REPORT

SUBJECT **SUBMISSIONS ON PROPOSED HUAPAI NORTH VARIATION FROM PUBLIC OPEN DAYS**
 FILE REF TP/14/4/127

To present the Committee with a summary of feedback received from recent public open days during which concepts for the proposed Huapai North Variation were available for viewing, and to recommend changes to the concepts in the variation following consideration of that feedback.

2.2.1.2.5 Density to support a retirement village

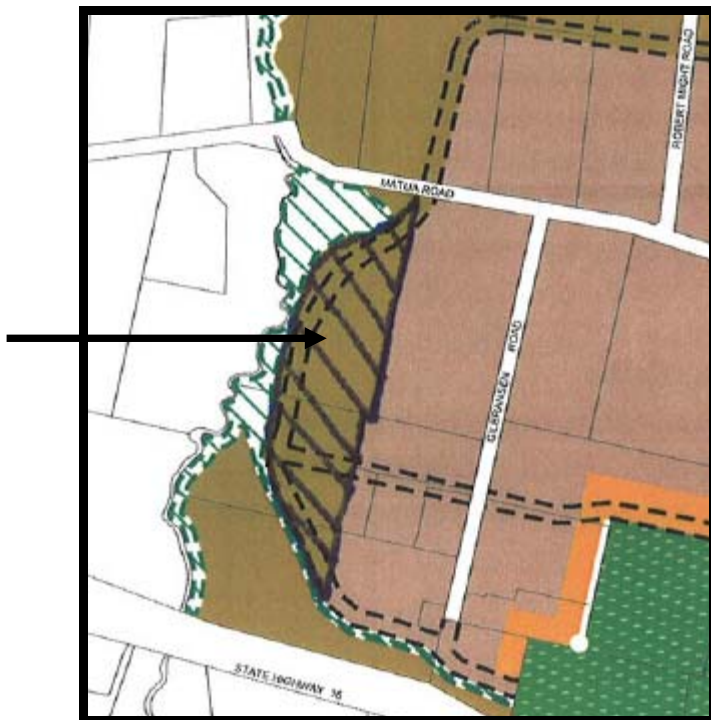
Submitter 18 owns land on the western extent of Huapai North at the end of Gilbransen Road, adjacent to Coopers Creek and fronting Matua Road and Coopers Creek. It is their intention to develop the sites in two parts, comprising a residential subdivision for the Matua Road frontage with section sizes averaging 780m² and a retirement village in the south western area of land. This is shown in the following concept plan that was attached to the submission:

With regard to density, the submitters requested that the land fronting Matua Road be able to be developed to the intensity sought (780m²) and similarly that retirement villages be provided for on their land. Retirement Villages are discussed later in this report. With regard to the density proposed of 780m² for the site fronting Matua Road, it is considered that this would not be entirely consistent with the outcomes sought of minimising potential reverse sensitivity effects on rural land to the west or creating a transition of density to the rural land beyond.

As can be seen on the plan below, if the indicative road could be the boundary between Low and Medium Intensity, and if it fronted Open Space, it would form a buffer between the zones to some extent. This proposed change would result in the following area being defined as Huapai Medium Intensity Policy Area, as shown below (cross hatched), although the indicative reserve would need to be extended to meet the road and the road would need to be fixed in that location with no variance. It is also noted that this is the only area of Low Intensity land within the 'ring' road around the Huapai North Area.

Recommended change
from Low to Medium
Intensity Residential.
(hatched area)

- That Integrated Residential Developments not be included in the proposed variation.
- That the area of land adjacent to Coopers Creek and south of Matua Road shown as 'hatched' above be identified as Huapai Medium Intensity Policy Area with Indicative Reserve up to the road, and that the rule package reflect the fixed location of the indicative road.
- That the proposal to allow for 15% of the Medium Intensity policy area to be developed to sites of 450m² - 600m² be retained within the rule package for notification due to the small number of submissions regarding this proposed area.

2.2.1.2.6 Reverse sensitivity

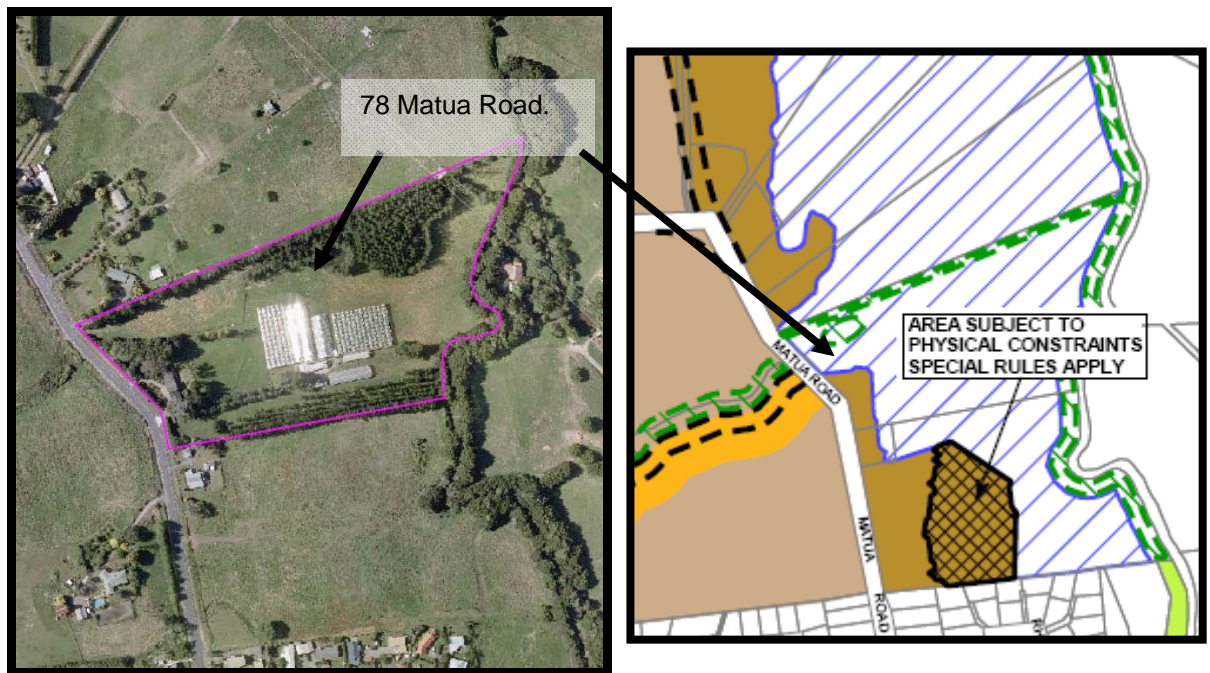
Submitter 34 operates a commercial flower growing business at 78 Matua Road and has done so for 23 years. This submitter has some concerns with regards to the proposed housing for the land bordering the flood zone, in particular the close proximity of housing to his family business, effectively reverse sensitivity i.e. from the use of lights during the night. The submitter states that the site was chosen to locate the business because it was rural and well separated from urban zoning. The site is located in the area shown in the aerial photograph below.

As shown in the proposed outline plan below, two corners of the site are proposed as Huapai Low Intensity Residential Housing. It is recommended that a decision on the zone of the land on this side of Matua Road, close to the site, be determined following discussions with this landowner regarding the existing effects generated by the business.

- That no changes be made in regard to the zoning of 78 Matua Road at this time, but that a decision on the zone of the land on this site and potentially other land within close proximity be determined following discussions with the landowner and business operators regarding the existing effects generated by their business.

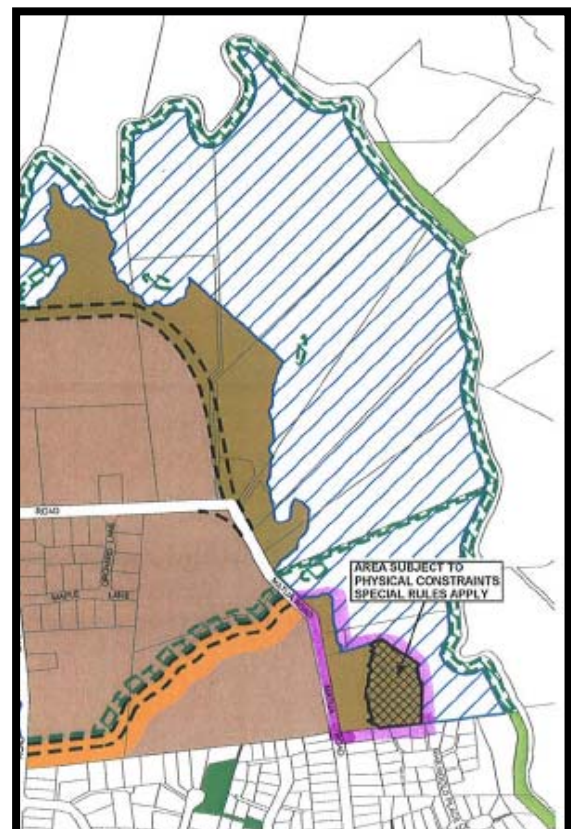
The landowners of 3 Matua Road, being Lot 1 DP 59461, have requested that their site be rezoned from Huapai Low Intensity Residential Policy Area to Huapai Medium Intensity Residential Policy Area. The site is identified in the plan adjacent with a purple outline, although the site excludes the ‘dog leg’ to the north.

The applicants stated that it has always been their expectation that the site will be medium intensity and that they currently had an application lodged with the Council and on hold to develop the site.

The concept for Huapai North included this site as Low Intensity, being 1500m² plus sites, as it formed the rural fringe. However, on further consideration it is noted that this site and the small area to the north are located within walking distance of the Huapai town centre, will adjoin medium intensity sites on two sides and are physically separated from other Low Intensity sites by the flooding and constraint area. The exact boundaries shown in the concept plan do not align directly with the submitters proposed subdivision plan; however, this is a matter that can be discussed with the submitters.

- That the area in the vicinity of 3 Matua Road, outlined in purple in the plan above, be identified as Huapai Medium Intensity Residential Policy Area.

2.2.1.4.12 Staggered intersections

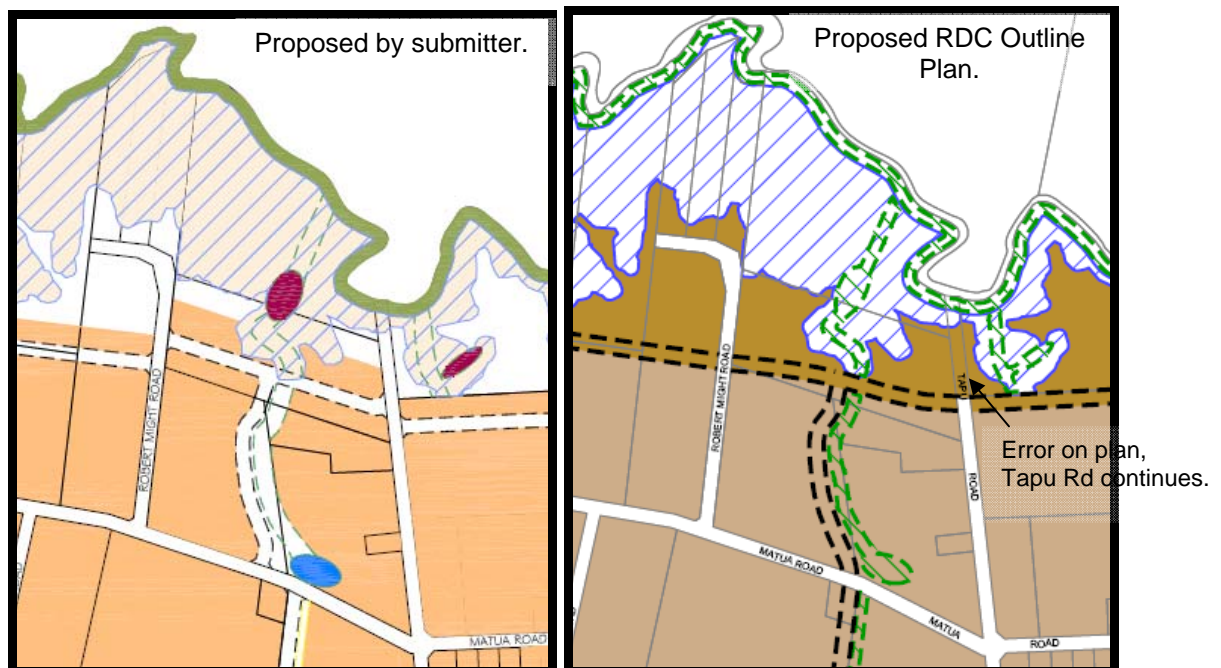
The submitter (40) requested that all 'X-intersections' be staggered to create 'T-intersections' and to align indicative roads with existing property boundaries as much as possible. The submitters considered that this was more consistent with Council's Engineering Standards and would improve sightlines and safety. In this regard, consideration should be given to moving the indicative road that connects Tapu Road with Gilbransen Road.

Although further consideration will be given to the safety of the roading network and consultant traffic engineers have been engaged to determine whether the network is safe and efficient, it is considered inappropriate to stagger all 'X-intersections' at this time. Furthermore, safety and efficiency need to be balanced with amenity values and the rural village character sought, rather than being considered in isolation.

- Overall, it is recommended that this submission be brought to the attention of the consultants reviewing the internal roading network for the area, but that no changes be made at this point in time.
